**Bernard Drive Contract 1 Project Addendum #2**

**TO:** Prospective Respondents and Other Interested Parties  
**FROM:** The Village of Buffalo Grove Finance Department  
**ISSUE DATE:** November 8, 2023  
**SUBJECT:** ADDENDUM #2

The following changes and clarifications shall be made to the Bid Documents for the Bernard Drive Contract 1 Project.

TITLE: **BERNARD DRIVE DRAINAGE PLAN AND PROFILE**  
 SCALE: 1:20  
 SHEET 6 OF 8 SHEETS STA. 81+00 TO STA. END  
 SECTION: 20-00108-01-RS  
 DATE: 11/7/2023  
 SHEET 28 OF 97

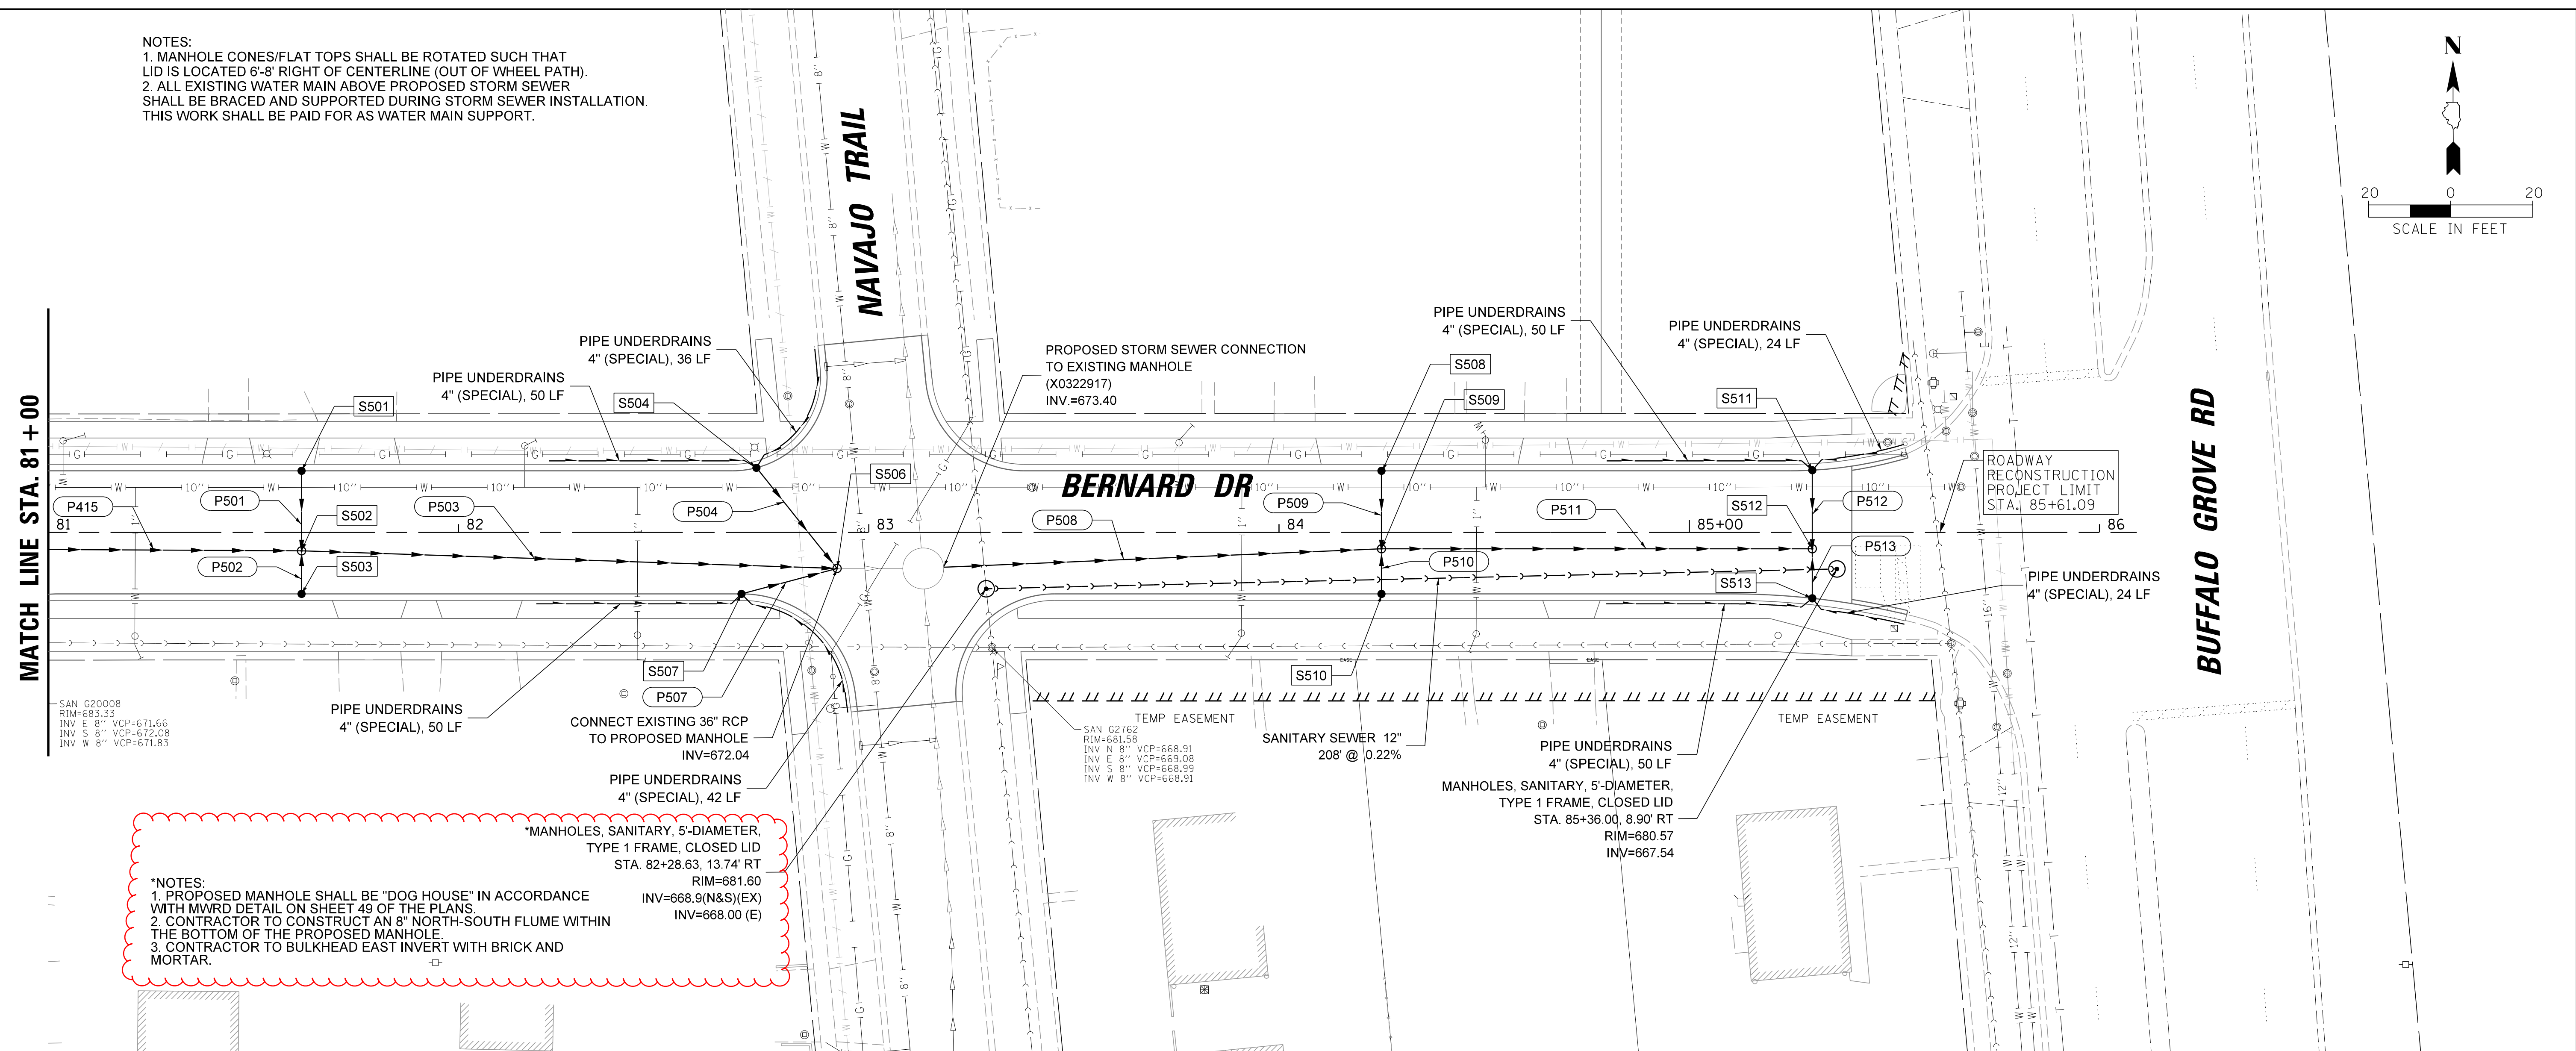
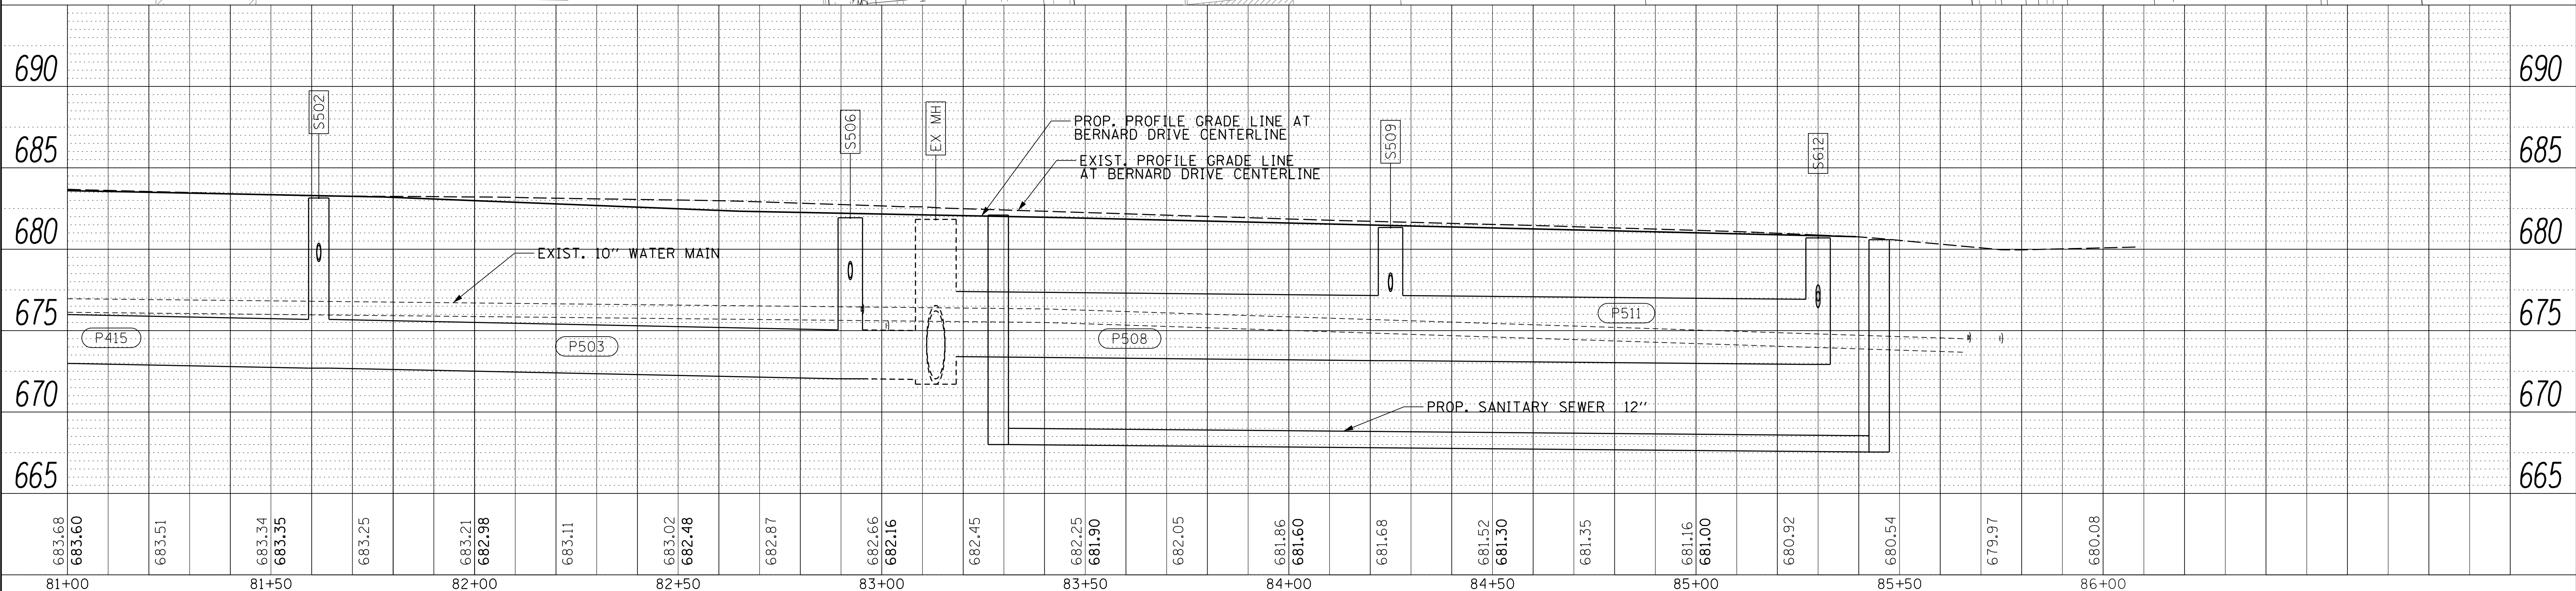
Additional information is being provided regarding the proposed sanitary sewer manhole to be constructed at the intersection of Bernard Drive at Navajo Trail (Sta. 82+28.63, 13.74' Rt). The attached plan sheet (28 of 97) shall replace the plan sheet that was included in the bid plans. The cost of completing the work, as shown on the revised sheet, shall be included in the cost of MANHOLES, SANITARY, 5'-DIAMETER, TYPE 1 FRAME, CLOSED LID.

\*NOTES:  
 1. PROPOSED MANHOLE SHALL BE "DOG HOUSE" IN ACCORDANCE WITH MWRD DETAIL ON SHEET 49 OF THE PLANS.  
 2. CONTRACTOR TO CONSTRUCT AN 8" NORTH-SOUTH FLUME WITHIN THE BOTTOM OF THE PROPOSED MANHOLE.  
 3. CONTRACTOR TO BULKHEAD EAST INVERT WITH BRICK AND MORTAR.

\*MANHOLES, SANITARY, 5-DIAMETER, TYPE 1 FRAME, CLOSED LID  
 STA. 82+28.63, 13.74' RT  
 RIM=681.60  
 INV=668.9(N&S)(EX)  
 INV=668.00 (E)

TITLE: **BERNARD DRIVE**  
**EXISTING CONDITIONS AND REMOVAL PLAN**  
 SCALE: 1:20 SHEET 2 OF 3 SHEETS STA. 63+00.00 TO STA. 75+00.00

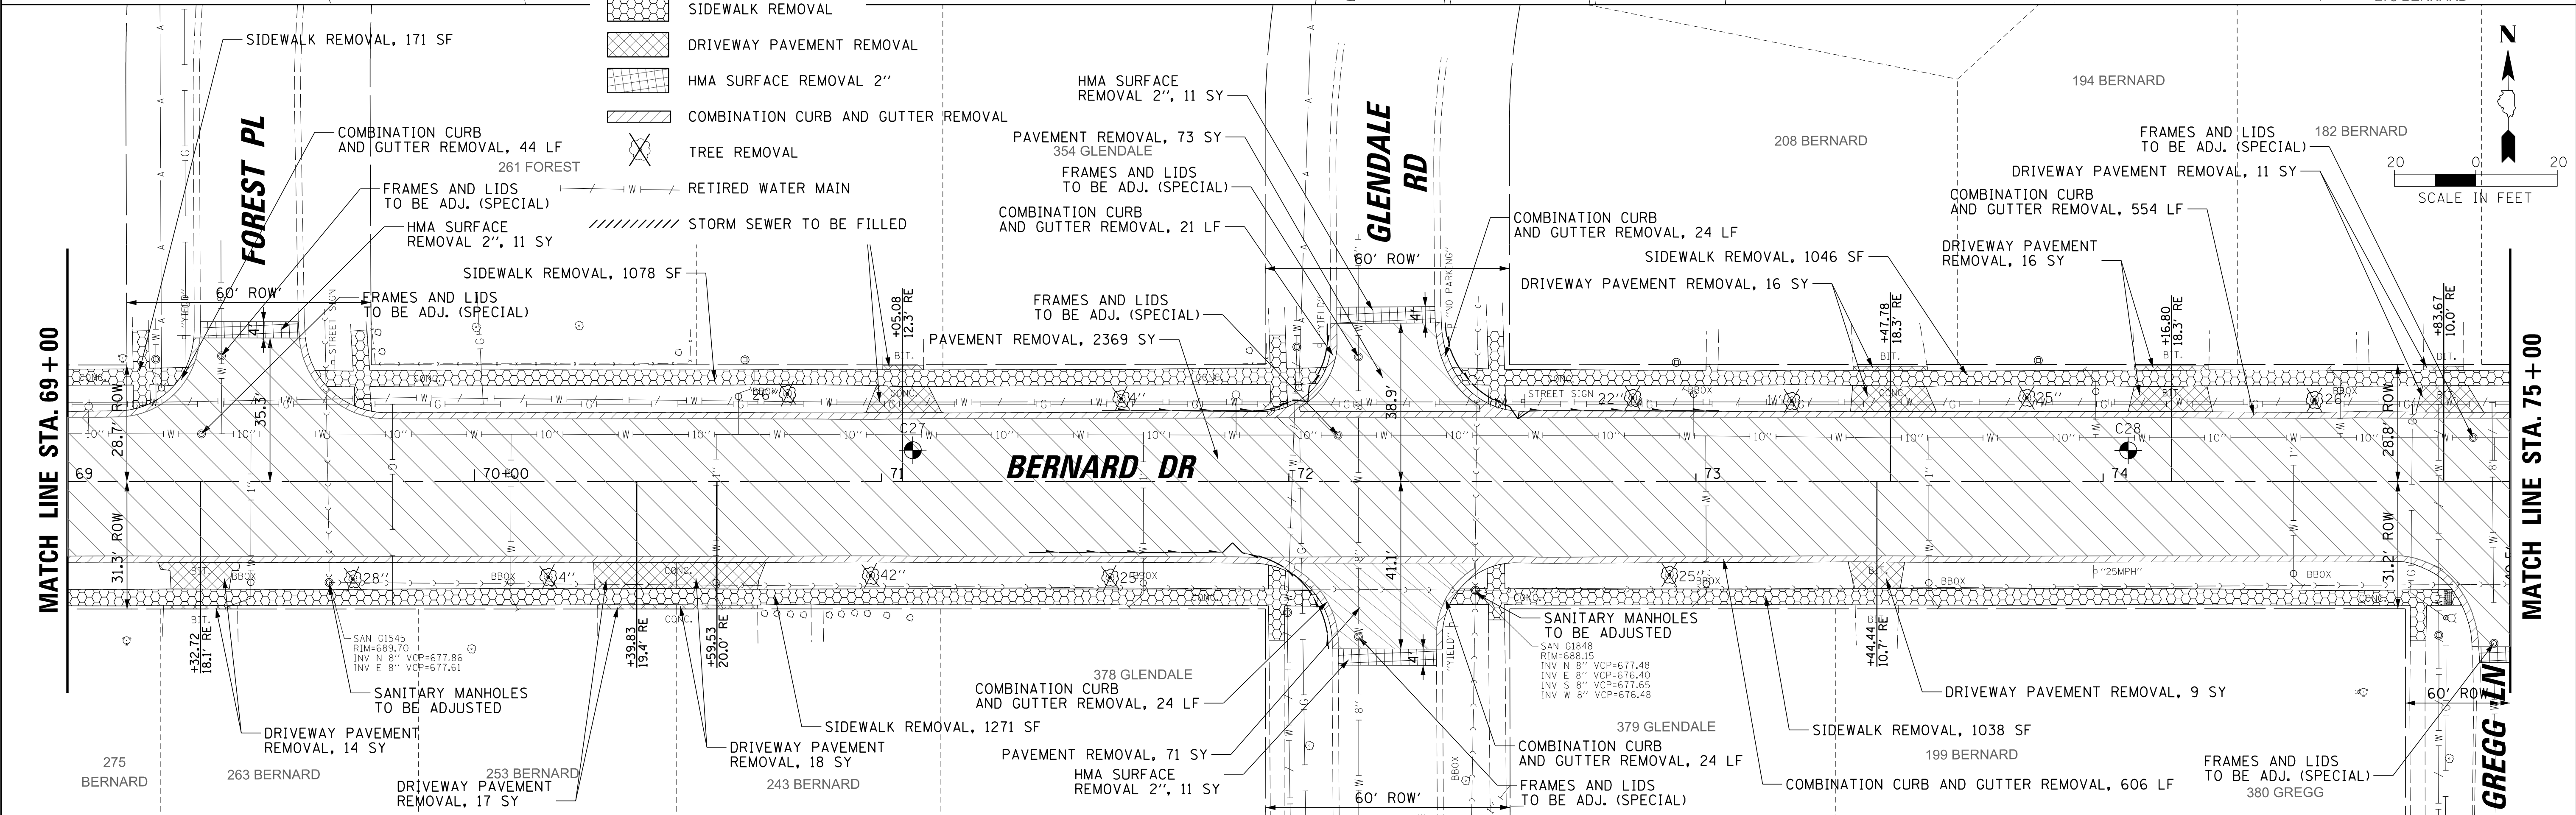
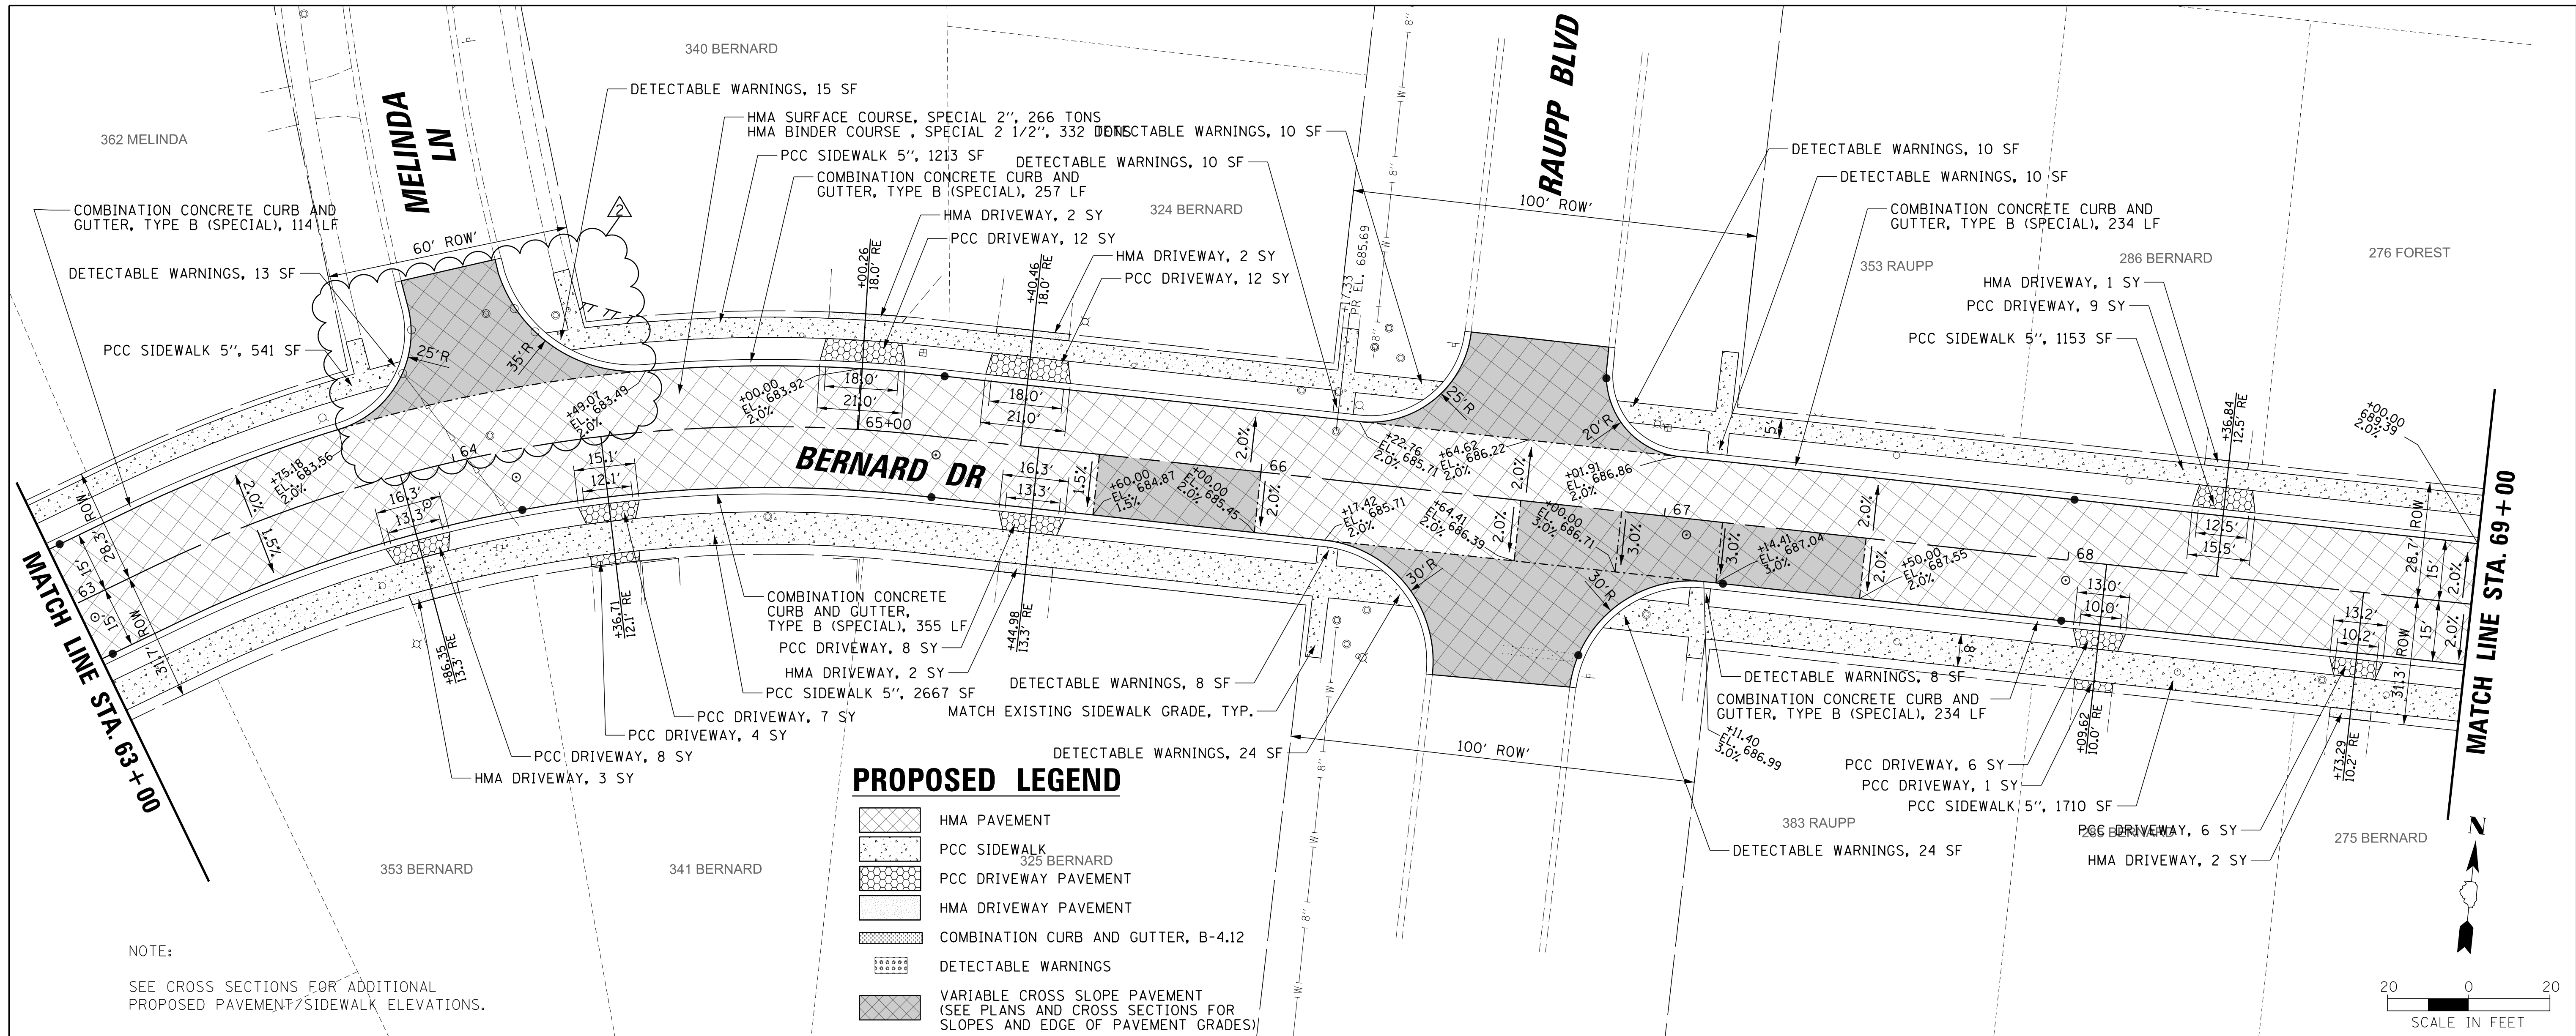
The quantity for INLET FILTERS (Item 7) has increased from 43 Each to 45 Each. A new pay item has been added for CATCH BASINS TO BE ADJUSTED (Item 40). The quantity for this work is 2 Each. This additional work is required because the limits of reconstruction on Melinda Lane have been extended north. Attached to this addendum are the following:

NO.	DATE	NATURE OF REVISION	CHKD.	DSGN.	VMR
2	11/07/23	EXTENDED REMOVAL LIMITS ON MELINDA		DWN.	MAK
				CHKD.	LMF
				USER NAME = nhowellindgren	
				PLOT DATE = 11/8/2023

TITLE: **BERNARD DRIVE ROADWAY PLAN AND PROFILE**  
SCALE: 1:20 SHEET 3 OF 6 SHEETS STA. 63+00.00 TO STA. 69+00.00

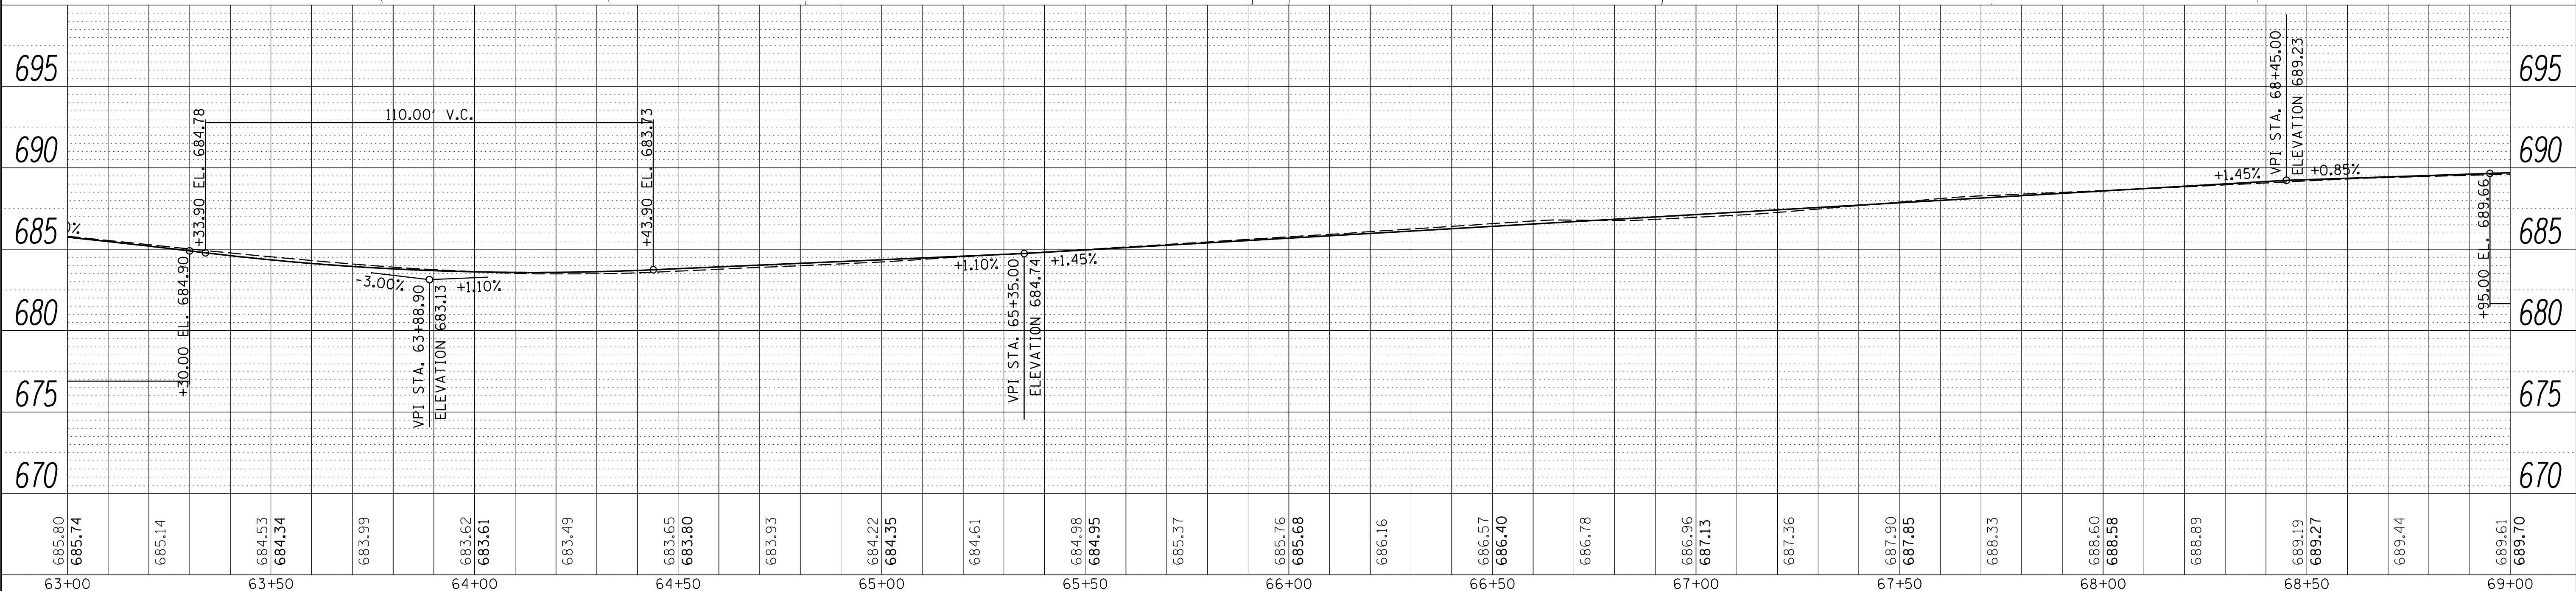
NO.	DATE	NATURE OF REVISION	CHKD.	DGN.	VMR
2	11/07/23	EXTENDED RECONSTRUCTION ON MELINDA		DWN.	MAK
				CHKD.	LMF
				USER NAME = rhowellindgren	
				PLOT DATE = 11/8/2023
